# **Technical Report - Supporting Data and Analysis for Skagit River RFIS Appeal**

March 2011

**City of Burlington  
City of Mount Vernon  
City of Sedro-Woolley  
Town of La Conner**

Pacific International Engineering, PLLC

Figure 8. Slope Section XS3 – Skagit River near Concrete, WA

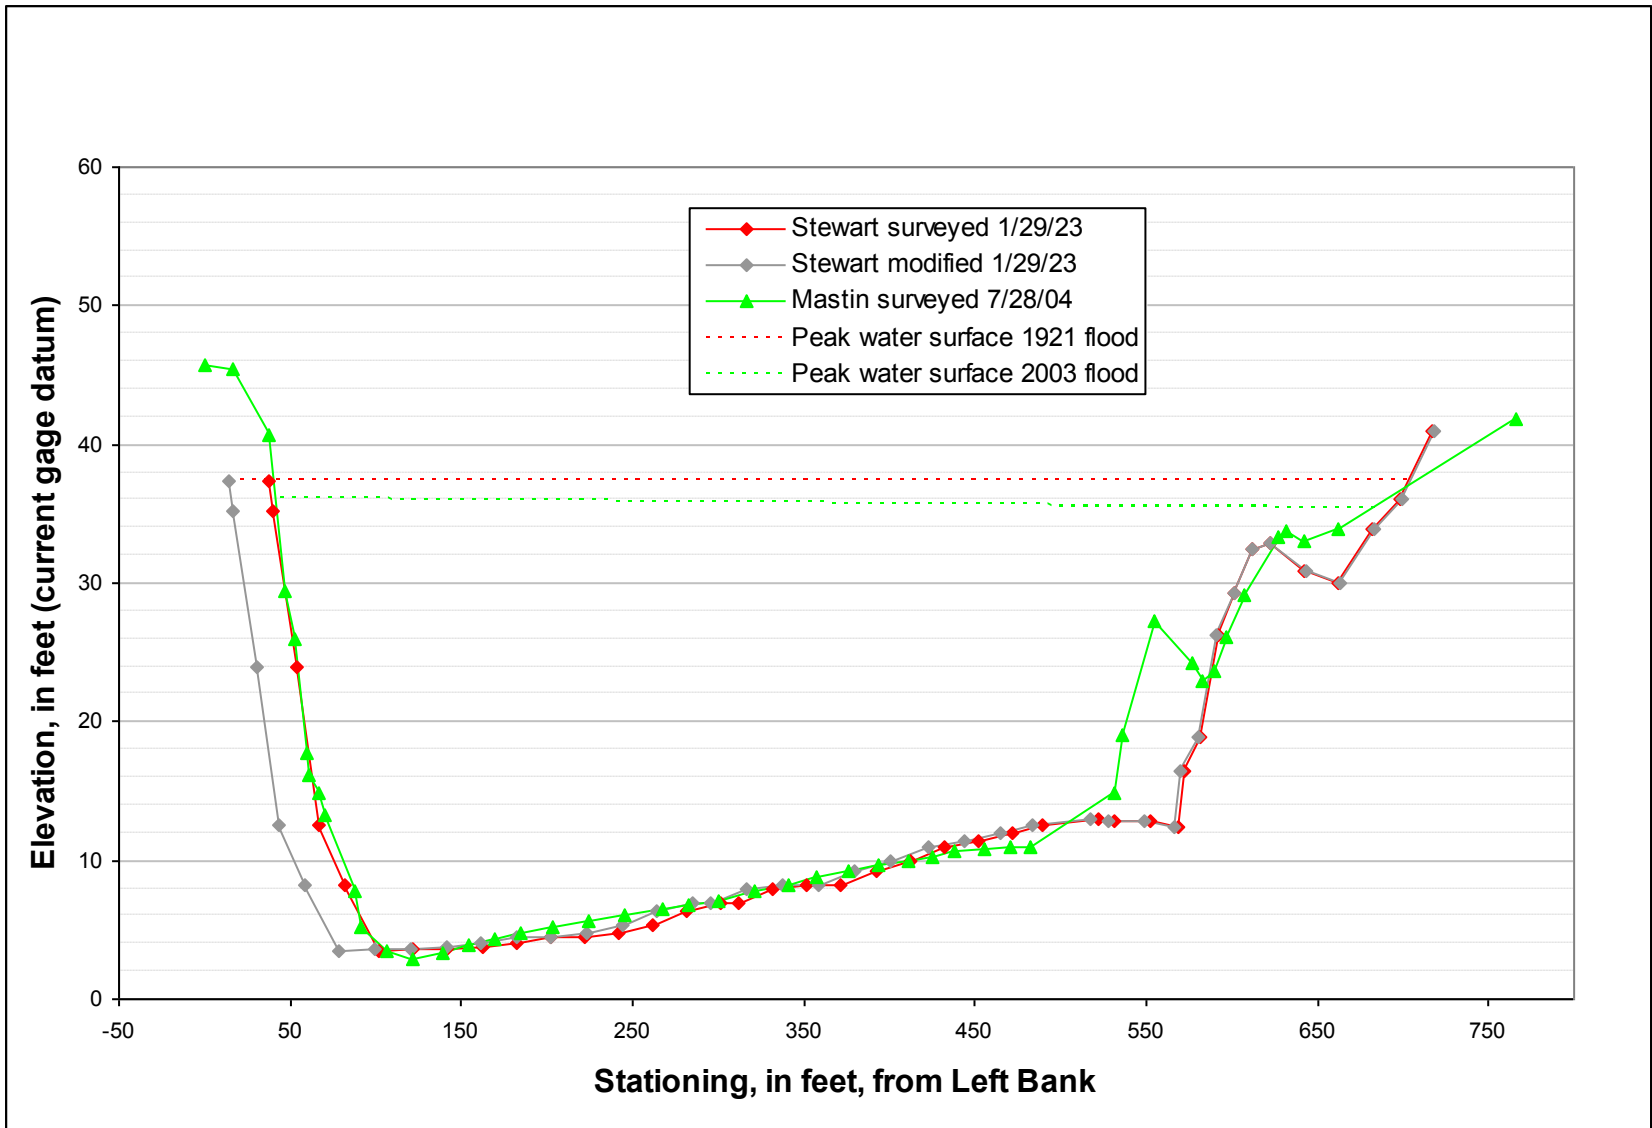
Figure 8 shows plots of Stewart’s originally surveyed and later-modified lower slope section. In 2004, the USGS (Mastin and his field crew) surveyed this section. The USGS 2004-surveyed lower slope section is also shown in the figure for a comparison. This comparison indicates that Stewart’s originally surveyed section appears accurate, matching the channel width and bottom elevations with the 2004-surveyed section better than his modified section. This comparison assumes that the 1923 and 2004 surveys are approximately at the same location, and that the change in cross section from 1923 to 2004 at this location is not significant.

As previously discussed (Section 2.2.5) and shown in Figure 6, it is our opinion that Stewart's originally surveyed XS3 is more accurate than his later-modified XS3. Stewart assumed his survey rope was stretched by approximately 5% when he was surveying XS3 and went ahead to modify his originally surveyed XS3 without an actual verification of his assumption. Stewart's assumption is incorrect based on a comparison with the USGS 2004 surveyed section at XS3 location as shown in Figure 8.

Figure 9. 1921 and 2003 flood high water marks surveyed by Stewart (in 1922-23) and USGS (in summer 2004)

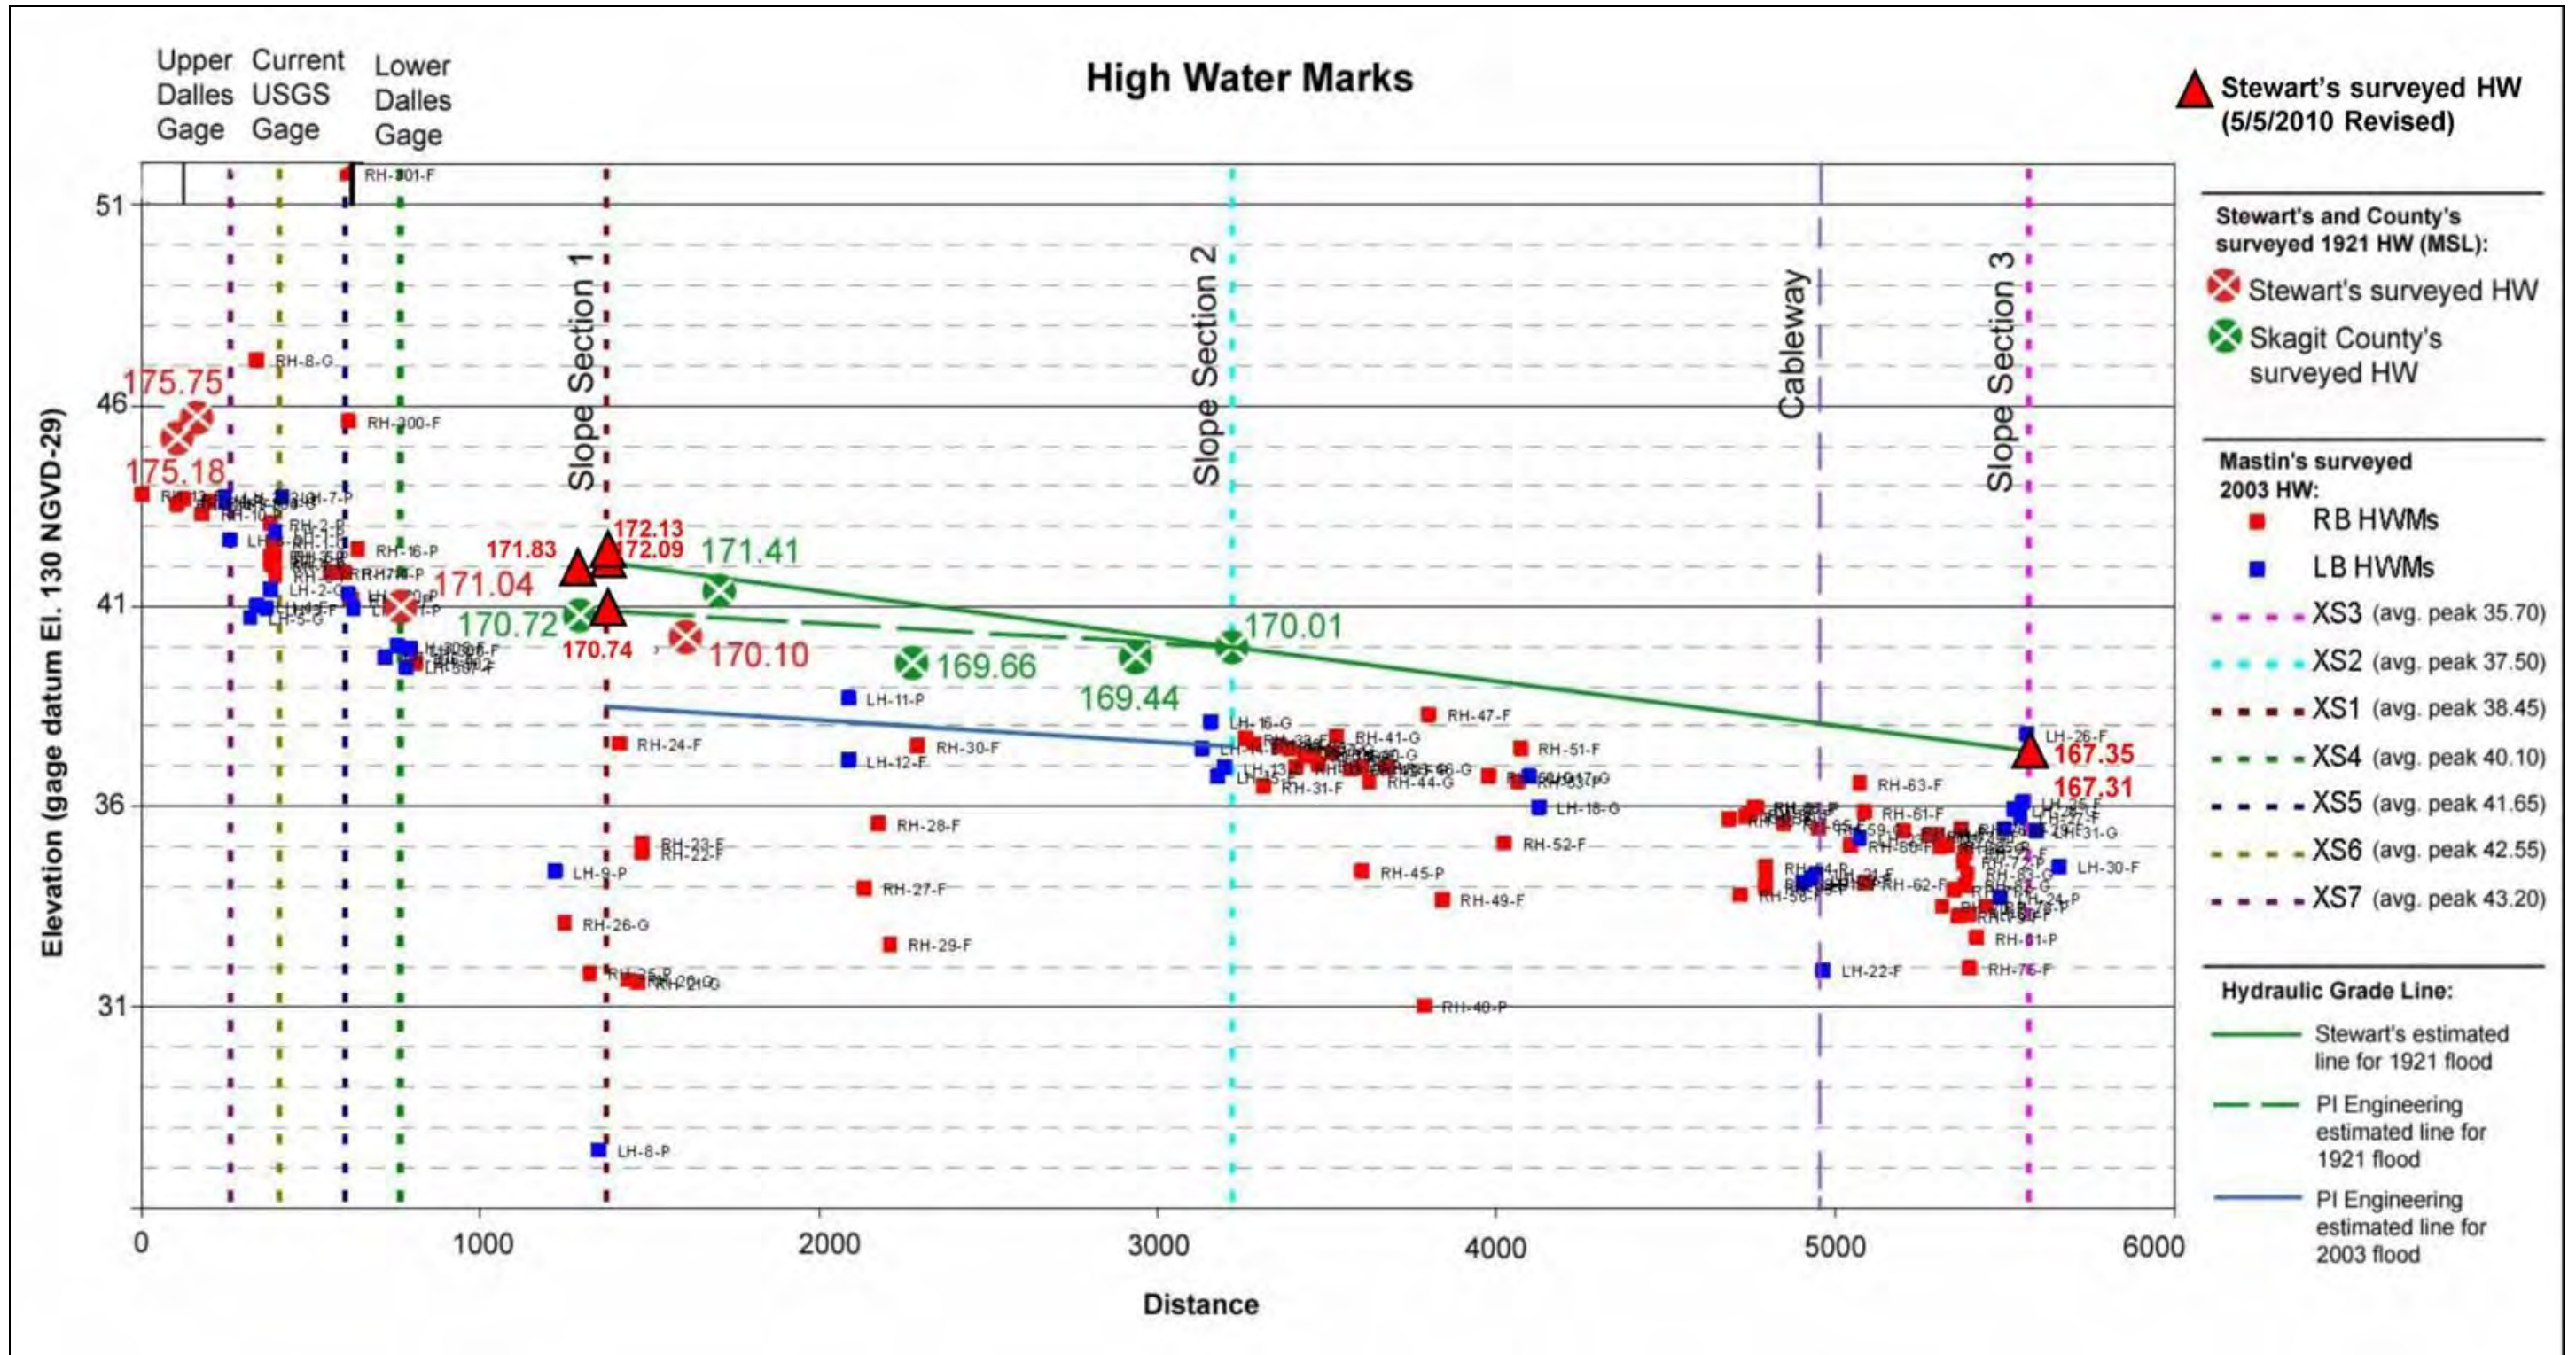
Figure 9 shows elevation plots of Stewart-surveyed 1921 HWMs (see Figure 1 for HWM location) and USGS-surveyed 2003 HWMs (surveyed in summer 2004 and provided by Mastin in the spreadsheet Concrete\_03\_SAM.xls) in the Dalles and slope-area reaches. The slope sections XS1 and XS2 are located below the Dalles at 618 and 2,479 feet, respectively (Stewart 1923, Exhibit B, p. 2). Stewart’s suggestion would exclude the use of the HWM data (particularly, the three higher data points, 171.83, 172.09 and 172.13, due to the residual of “the velocity head gained in The Dalles”) at XS1 located within the Stewart suggested 700 foot distance and not far enough below the Dalles to dissipate “all of the velocity head gained in The Dalles”.

Excluding the HWMs at XS1 and using the other HWMs below XS1, we interpolated a fall of the 1921 water surface between XS1 and XS2 to be 0.85 foot. The corresponding hydraulic grade line slope between XS1 and XS2 was then calculated to be 0.000457 (= 0.85/1860). As shown in Figure 9, the 2003 flood HWMs also support the flatter hydraulic grade line slope between XS1 and XS2. Using the USGS-estimated average peak elevations 38.45 and 37.50 provided in the spreadsheet and listed in Figure 9, we estimate the hydraulic grade line slope between XS1 and XS2 for the 2003 flood to be 0.000511 (= (38.45 – 37.50) / 1860), which is very similar to the above-estimated slope of 0.000457 for the 1921 flood.

The hydraulic grade lines used by Stewart for the upper and lower slope-section reaches (XS1–XS2 and XS2–XS3) are plotted on Figure 9, as well as those estimated by PI Engineering for the upper slope-section reach (XS1–XS2). Our comparison assumes no revision to Stewart-used lower

reach hydraulic grade line, which likely has great uncertainties as there are no intermediate HWM data available between XS2 and XS3 from Stewart's survey to support this hydraulic grade line. (Note: in our view, a drop close to 2.0 ft from XS2 to XS3 based on the 2003 HWMs is more reasonable than the 2.62-ft drop used by Stewart and the USGS.)

**Figure 17. USGS published estimate of 1932 unregulated flood peak discharge at Concrete (source of data: Figure 4 – Hydrographs showing effect of dams on flood peak, USGS 1961)**

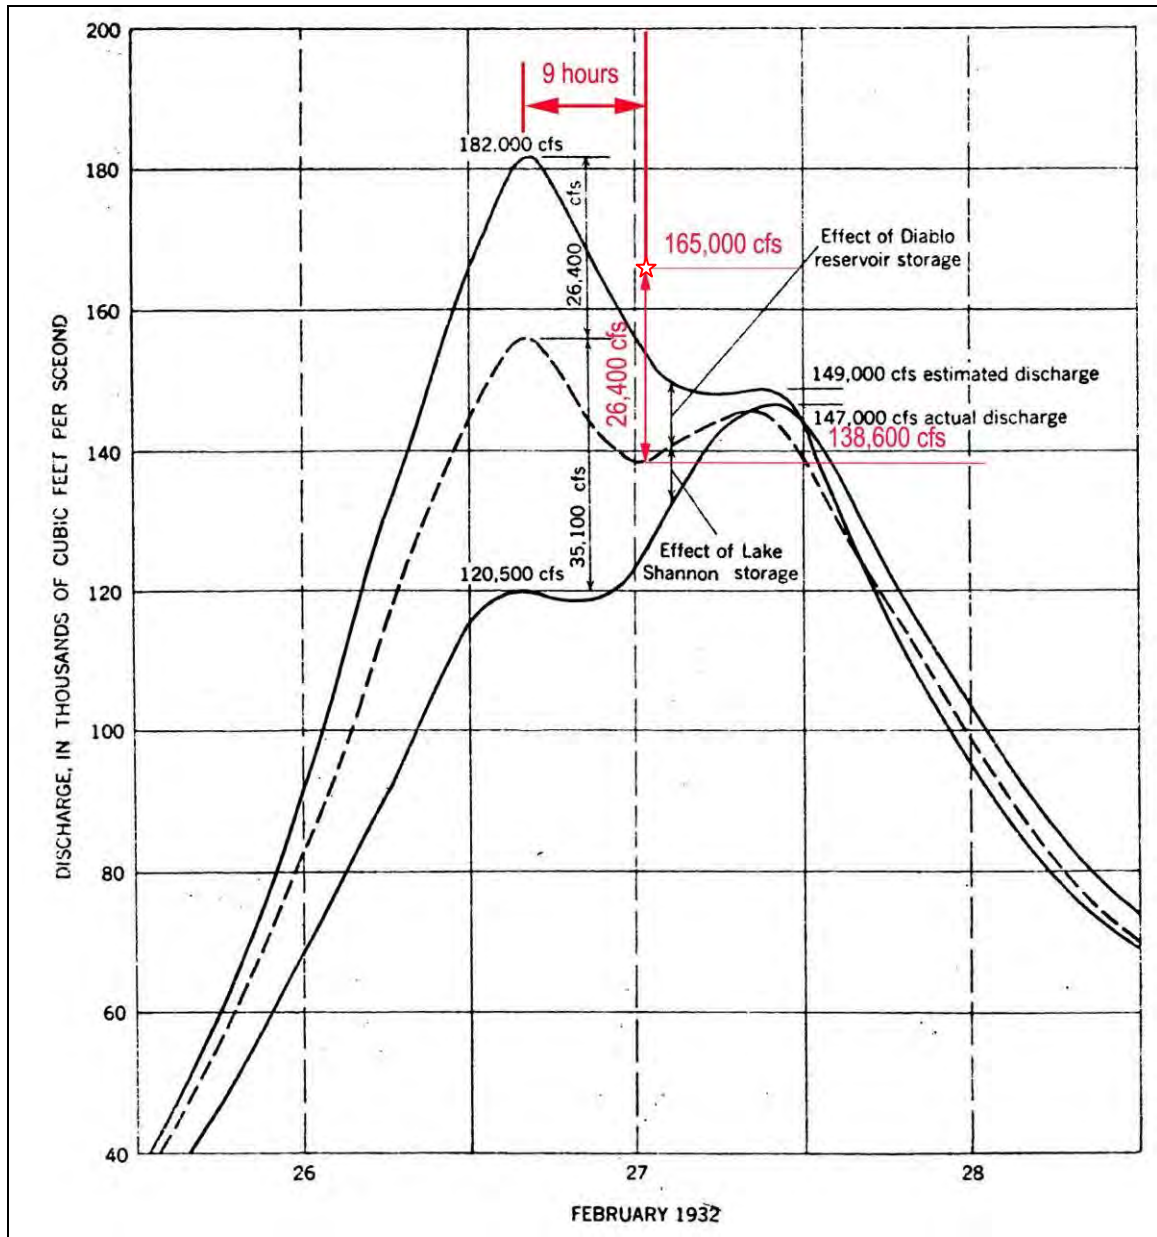
The RFIS flood frequency analysis uses an unregulated peak discharge for the 1932 flood, based on an estimate made by USGS and published in the Water Supply Paper 1527 (USGS 1961). Figure 17 is the figure from Water Supply Paper 1527 (USGS, 1961, Figure 4) showing the USGS’ estimate. The USGS estimated unregulated peak discharge is 182,000 cfs, which is used by the Corps of Engineers in the RFIS hydrology analysis (USACE 2008). We believe this estimate is incorrect, as discussed below.

As shown in Figure 17, USGS estimated the effects of Diablo and Lake Shannon storage to be 26,400 and 35,100 cfs, respectively, on reduction of the peak flows occurring at the same time, approximately 4 to 5 AM on February 27, 1932. Adding these to the regulated 120,500 cfs observed at the Skagit River gage near Concrete at that time, results in the USGS estimated unregulated peak discharge of 182,000 cfs. The regulated peak flow actually recorded and published by the USGS at the gage is 147,000 cfs at about 10 PM on February 27, 1932.

The USGS unregulated peak of 26,400 cfs from Diablo reservoir as shown in Figure 17, was delayed by 9 hours to arrive at the gage near Concrete approximately at 1 PM on February 27, 1932. Adding this flow to 138,600 cfs scaled from the figure, which is the sum of the USGS unregulated flow from Lake Shannon and the flow observed at the gage near Concrete at 1 PM on February 27, 1932, results in the unregulated peak flow estimate of 165,000 cfs. Lack of details and data used in the USGS unregulated flow estimate prevents us from performing a complete hydrograph unregulation.

It is our opinion that our revised unregulated peak discharge of 165,000 cfs is more accurate than the USGS estimated 182,000 cfs for the 1932 flood.

**Figure 22. Right Bank Levees on Mainstem and North Fork Skagit River Removed While All Other Levees Remain Intact** (original source: Figure 9, COE 2009)

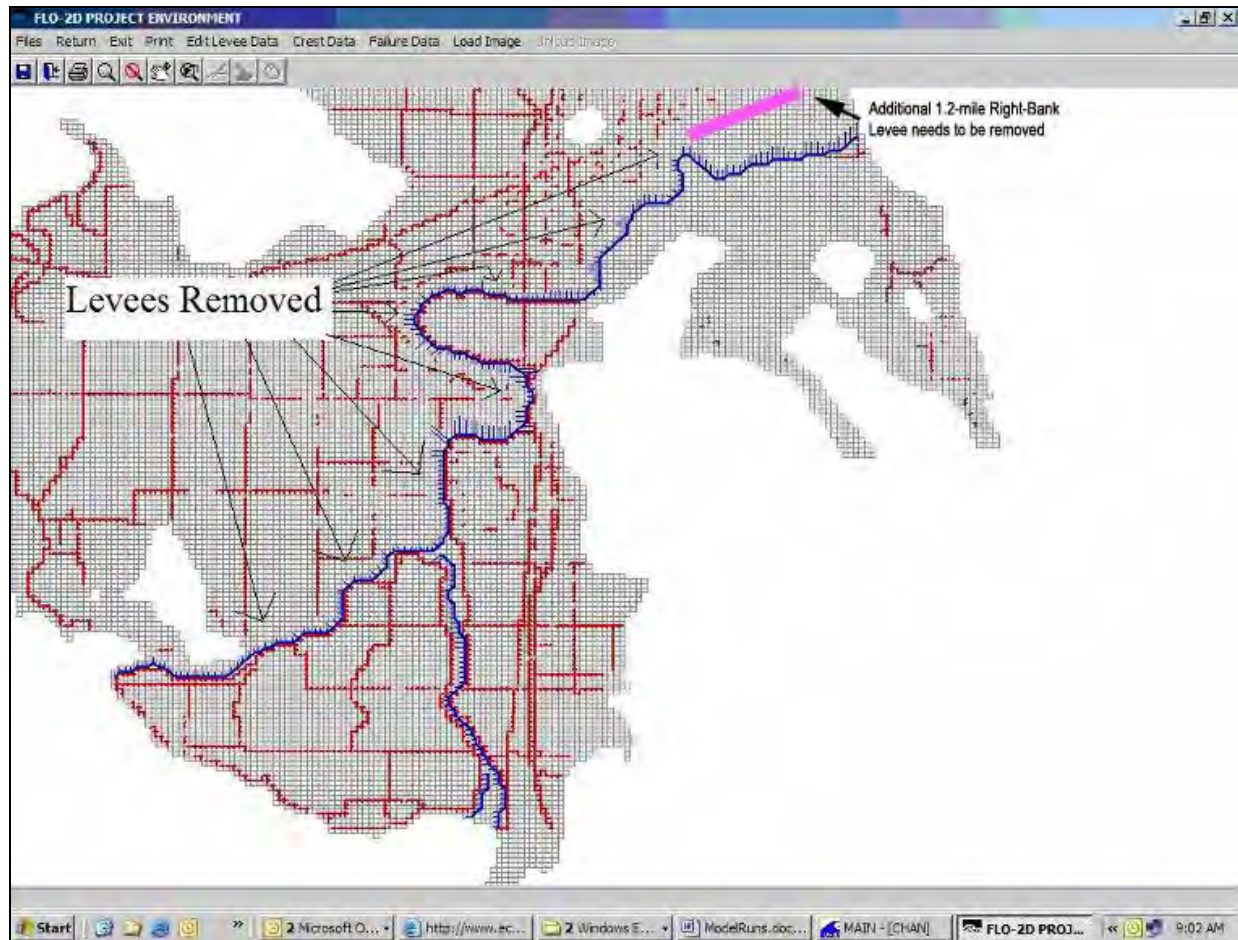
PI Engineering reviewed the model runs for these seven levee removal scenarios, and found that the levee methodology was inconsistently applied to the scenario shown in Figure 22 - Right Bank Levees on Mainstem and North Fork Skagit River Removed While All Other Levees Remain Intact. For this scenario, the removed right-bank levee starts upstream approximately at RM 21 in the current model. It is our opinion that an additional 1.2-mile levee (RM 21 – 22.2) upstream also needs to be removed, as annotated in the figure.

- (1) Extending the right-bank uncertified levee upstream for 1.2 miles along the SR-20 roadway and BNSF railway fill corridor including the 20-ft high dam at the Gages Slough inlet in the Sterling area as shown in Figure 22.

**Figure 23. Depiction of the Floodplain Scenario Location of Implementation (original source: Figure 11, COE 2009)**

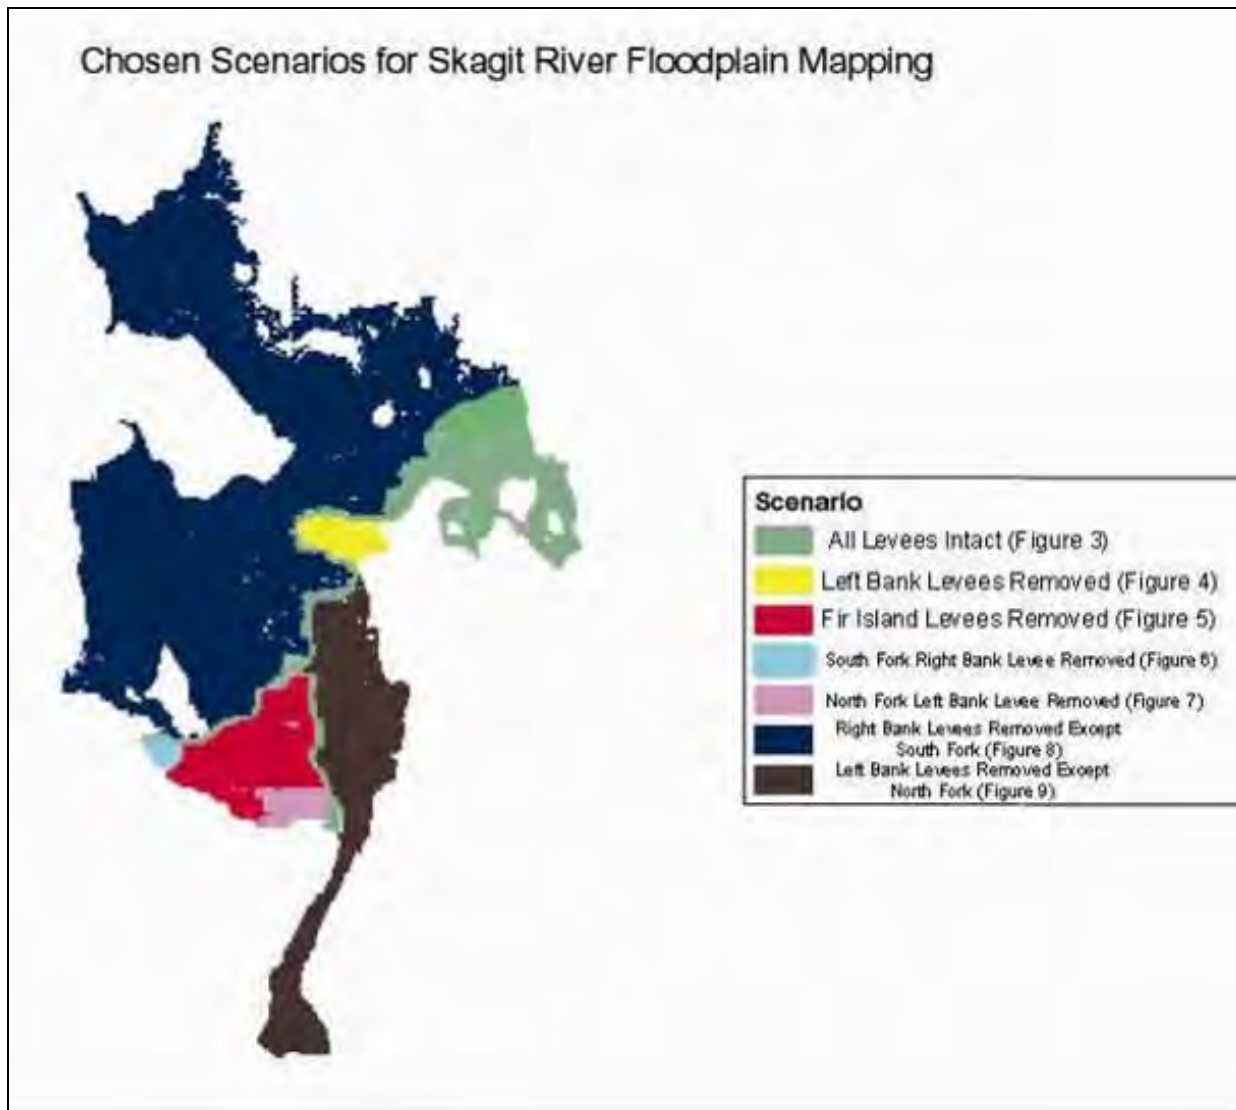
The flood mapping and modeling for the preliminary DFIRM and RFIS are not consistent in treating this fill reach. In mapping the floodplain, this reach was considered as a part of the right bank uncertified levee, as shown in Figure 23 (which is the Figure 11 of the COE hydraulics summary report, COE 2009). But when modeling the base flood elevations for the right bank floodplain, it was not included as a part of the right bank uncertified levee in the model. To correct this inconsistency, the right-bank levee removal scenario needs to extend upstream to include the removal of this 1.2-mile fill as an uncertified levee.
